WAT PRATHAT DOI SUTHEP
BUDDHIST TEMPLE OF NEW MEXICO
EPC SITE PLAN MAJOR AMENDMENT
DFT SIGN OFF

EPC MAJOR AMENDMENT DFT SIGN OFF DOCUMENT

Project # PR-2022-007851
SI-2022-02075 - Site Plan- Major Amendment

RE: PR-2022-007851, SI-2022-02075-Buddhist Temple, Site Plan – EPC Major Amendment

EPC A.1

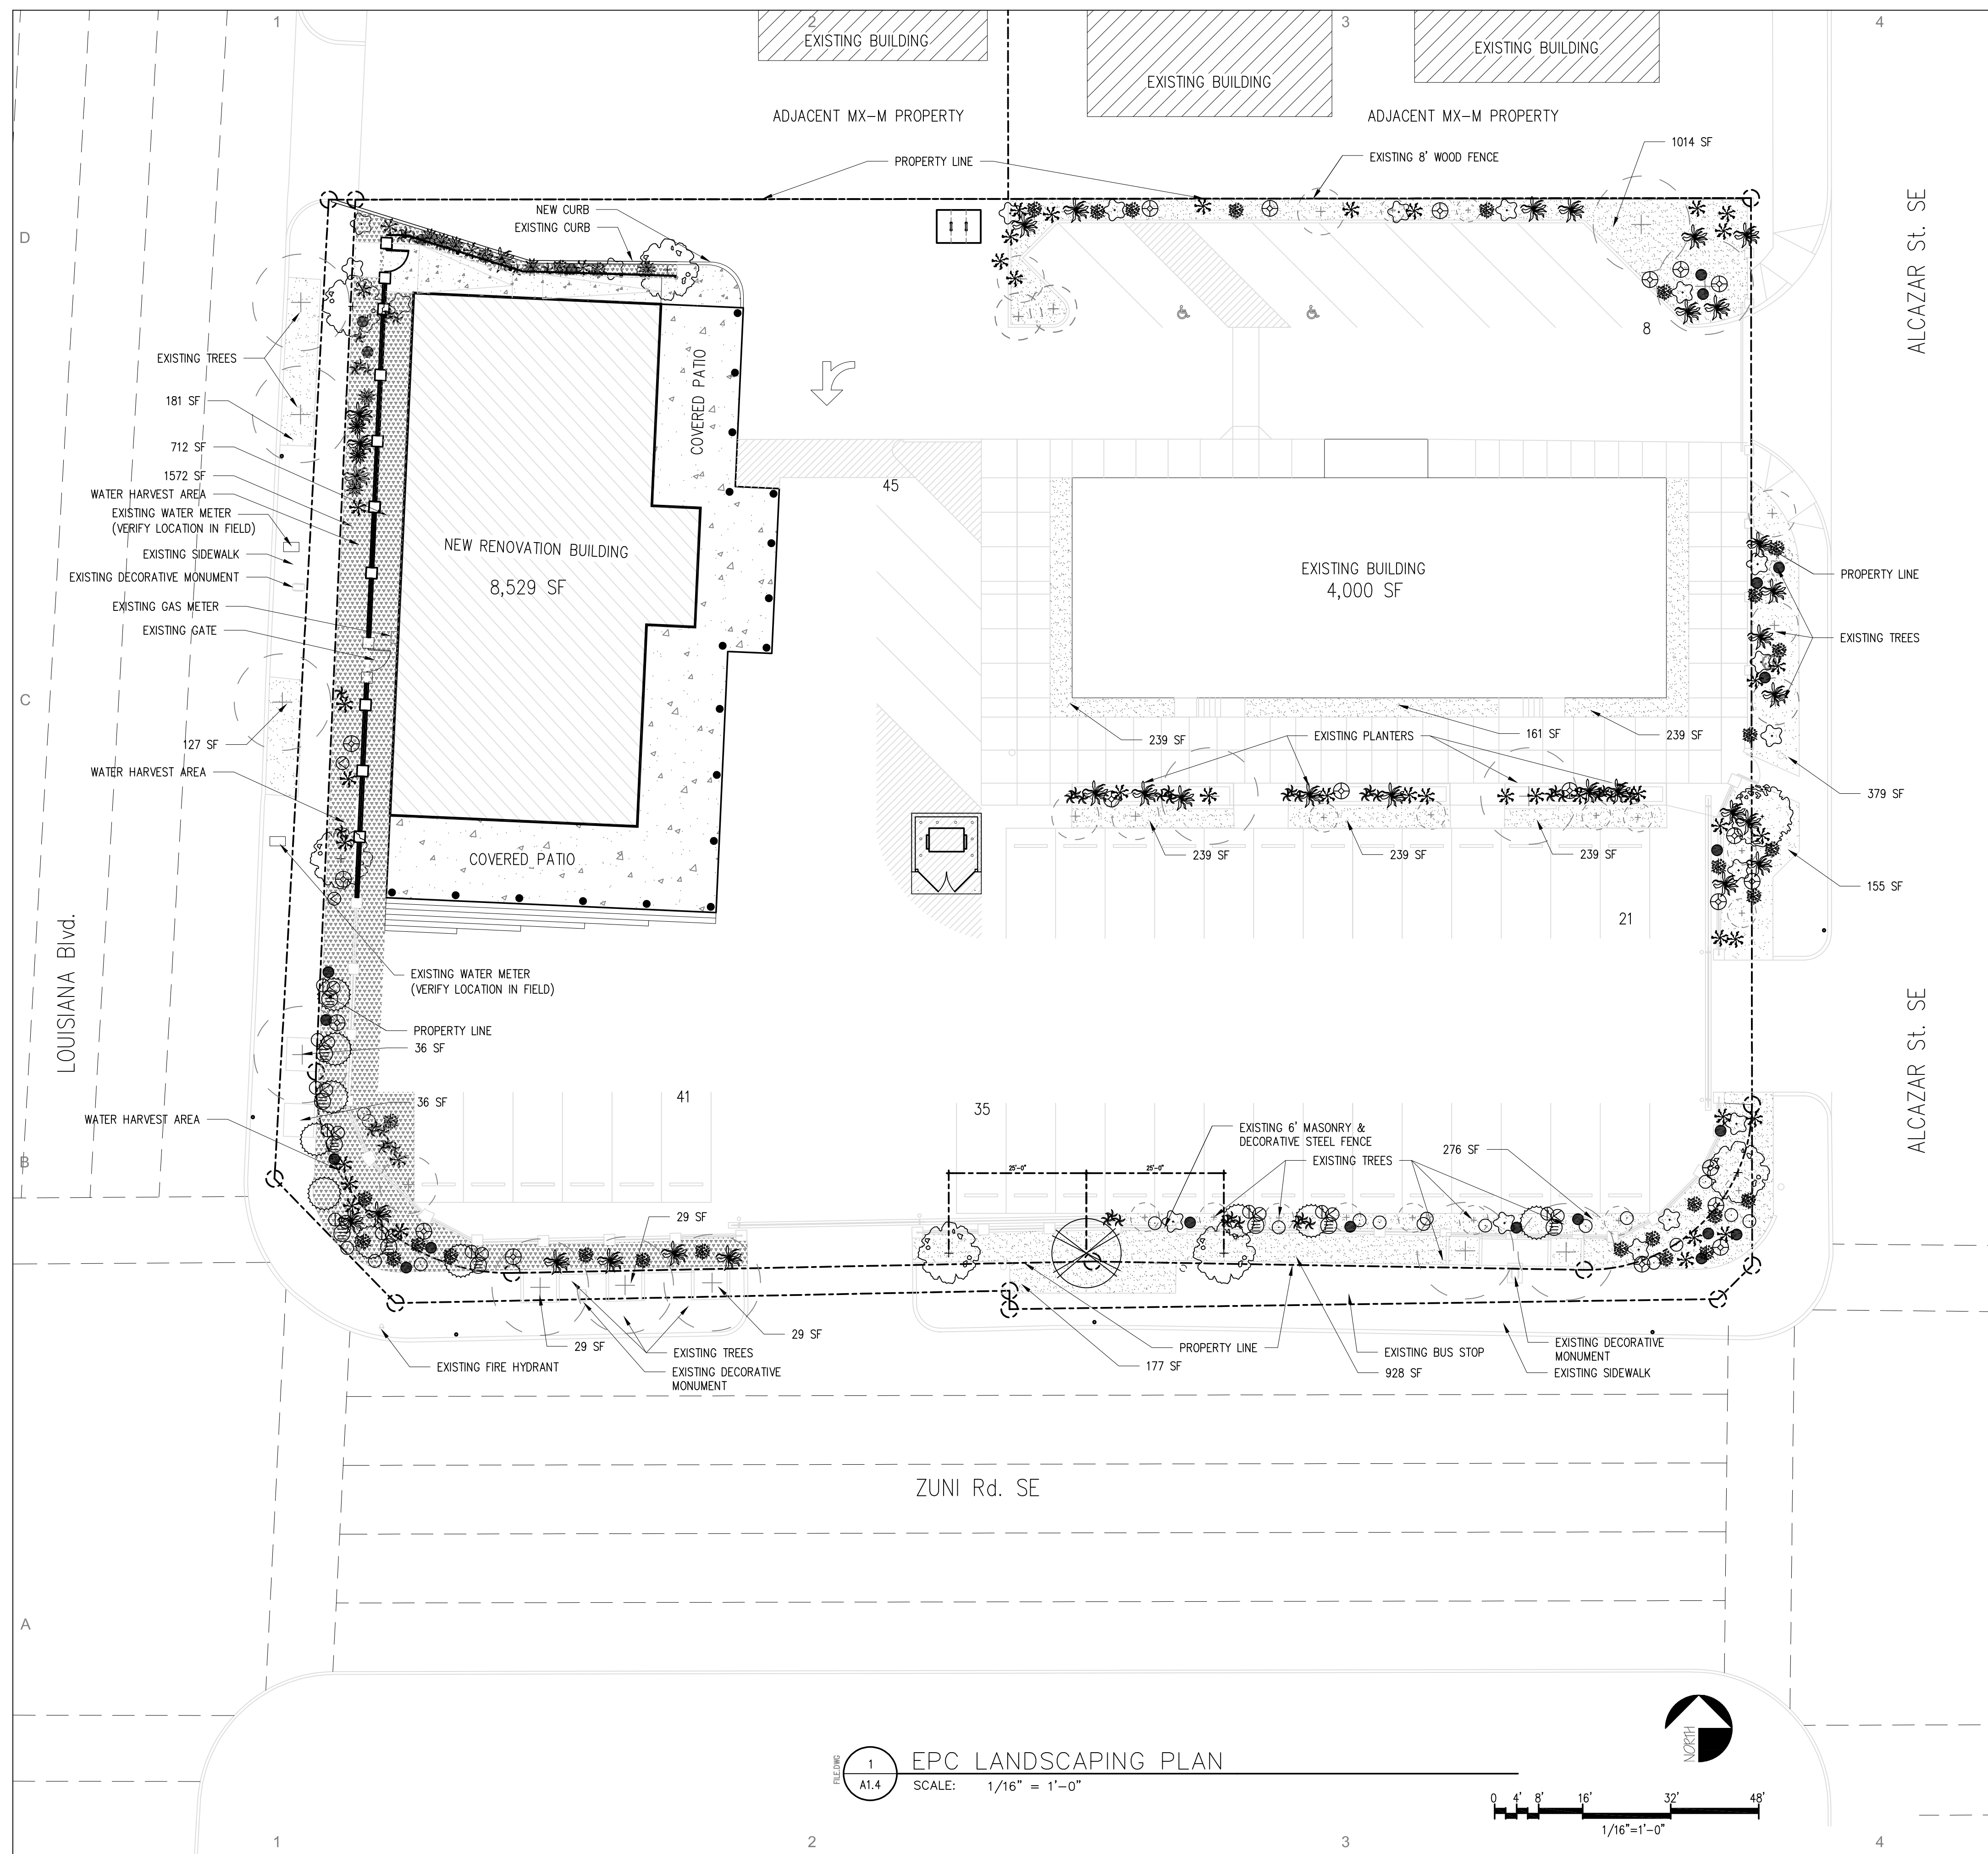
4. Site Plan: Site Plan must show all required dimensions including dimensions between light fixtures.
5. Wall/Fence height shall be subject to IDO standards unless a variance is obtained.

4. **Site Plan:** Site Plan must show all required dimensions including dimensions between light fixtures. The site plan reflects the required dimensions and annotates the site lighting at each CMU pilaster, both existing and new, are on a 12'-0" on center spacing along Zuni Road and Louisiana Boulevard SE. The covered patio of the residence is illuminated from fixtures on its exterior soffit. Existing solar landscape ground lighting remains in-place and will be augmented with new fixtures once the project is completed within the new landscaped areas.

SHEET TITLE:
EPC
LANDSCAPING PLAN
EPC A.2

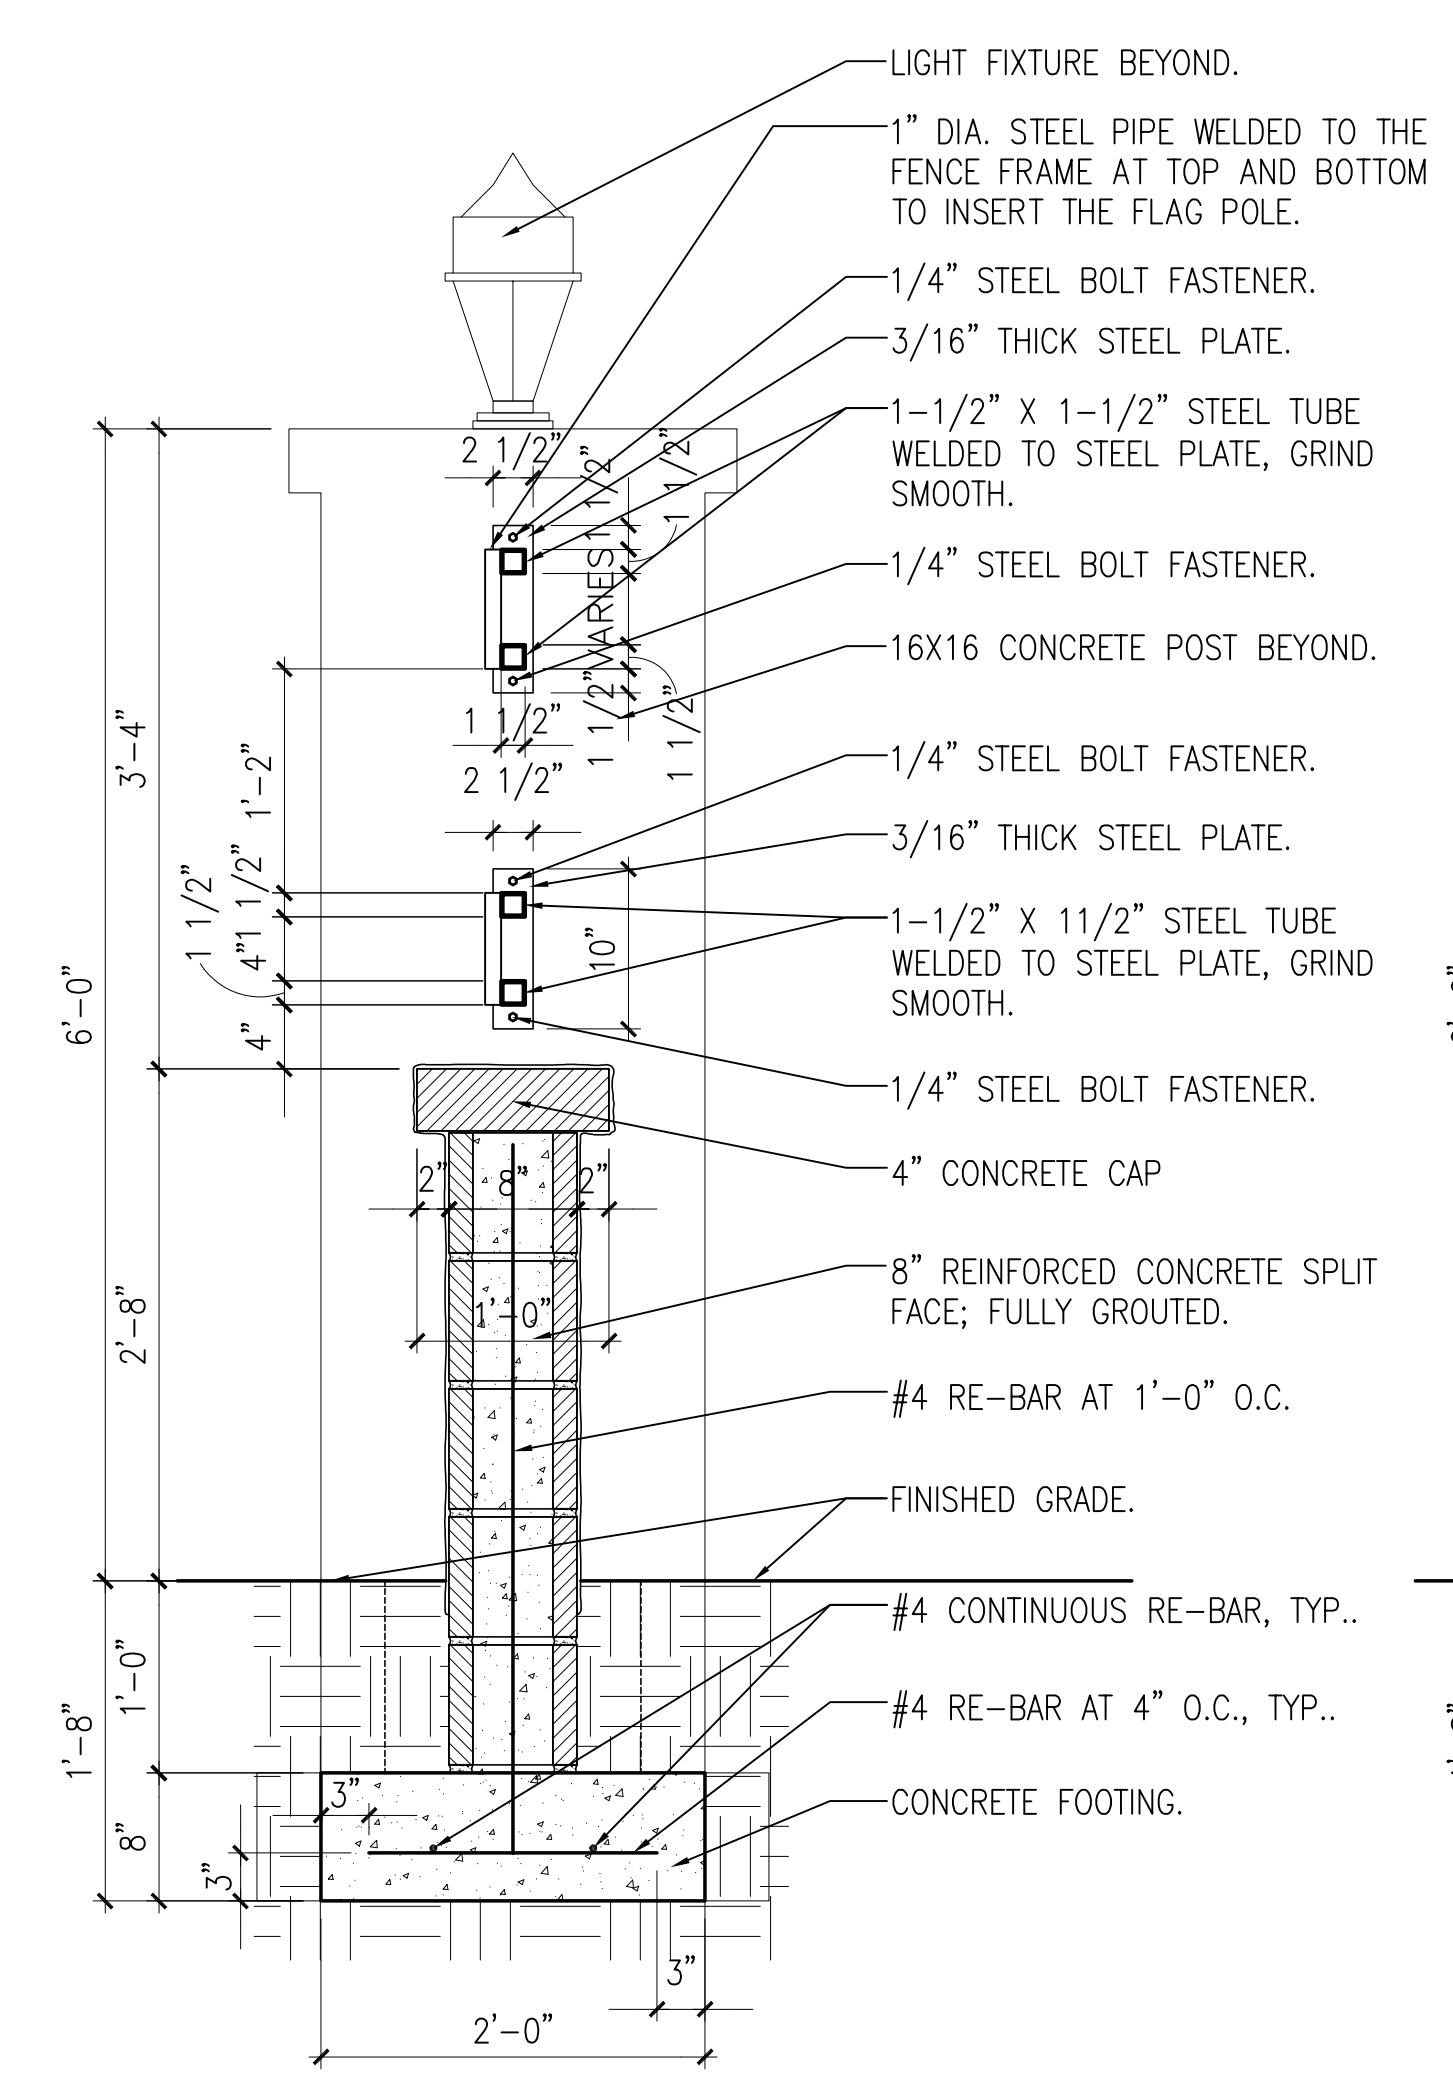
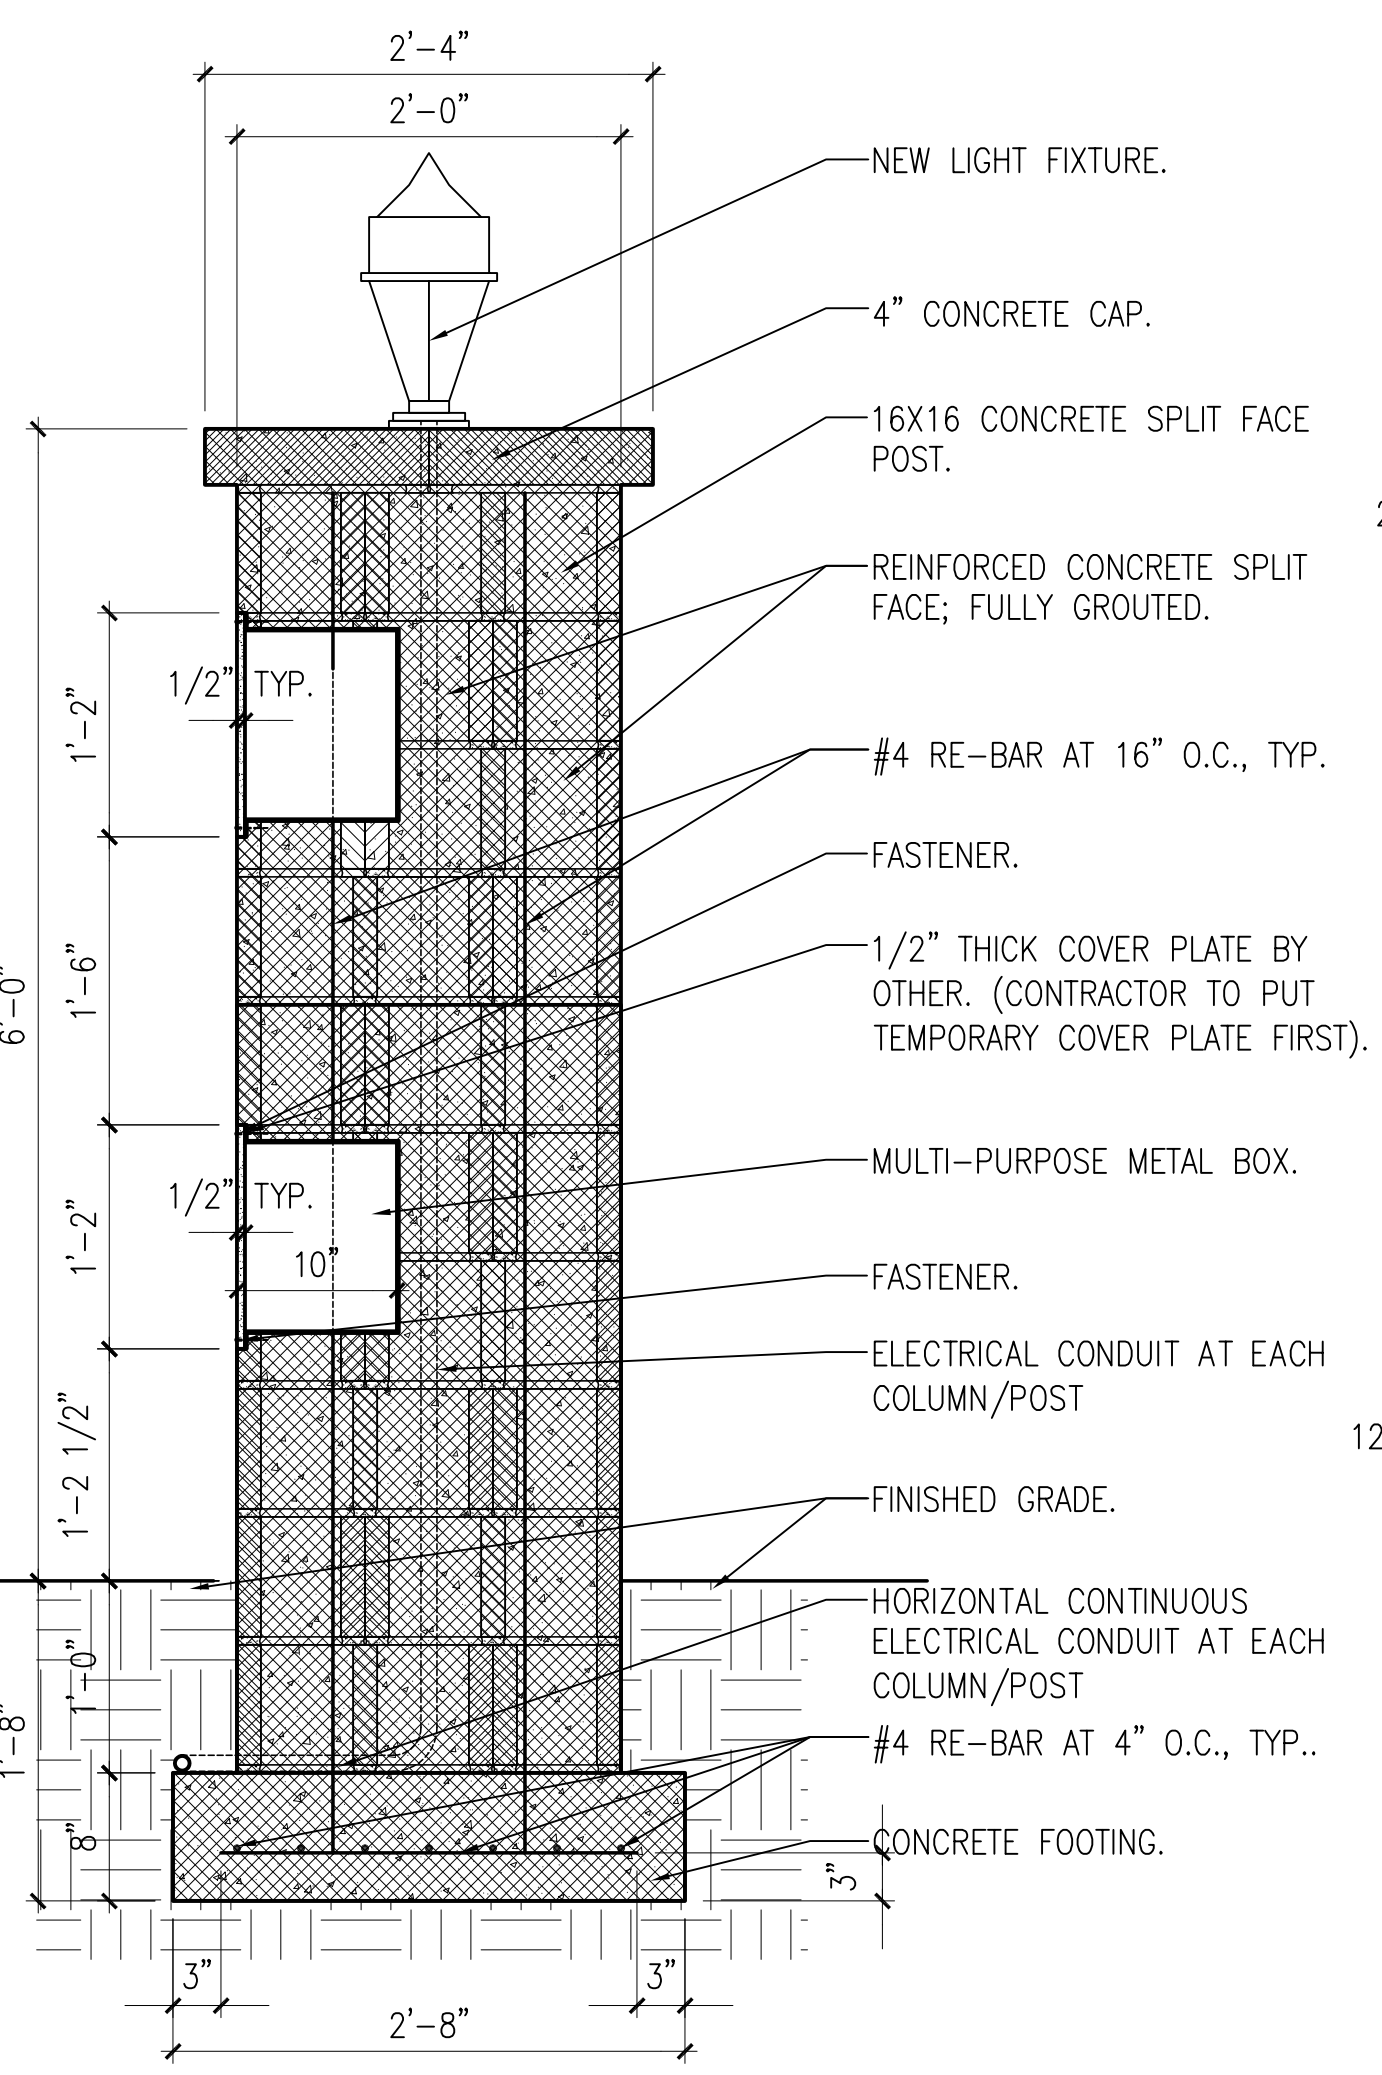
2. The applicant shall coordinate with the Staff planner prior to submitting for Building Permit.
3. Landscaping: The applicant must show that the required 75% of ground cover is being provided.

3. Landscaping: The applicant must show that the required 75% of ground cover is being provided.
The Site Landscaping Plan A-1.4 reflects that the required 15% landscaped area has plantings with trees and/or groundcovers over 75% of the landscaped areas. Site Area 49,658 SF (1.14 acres) less
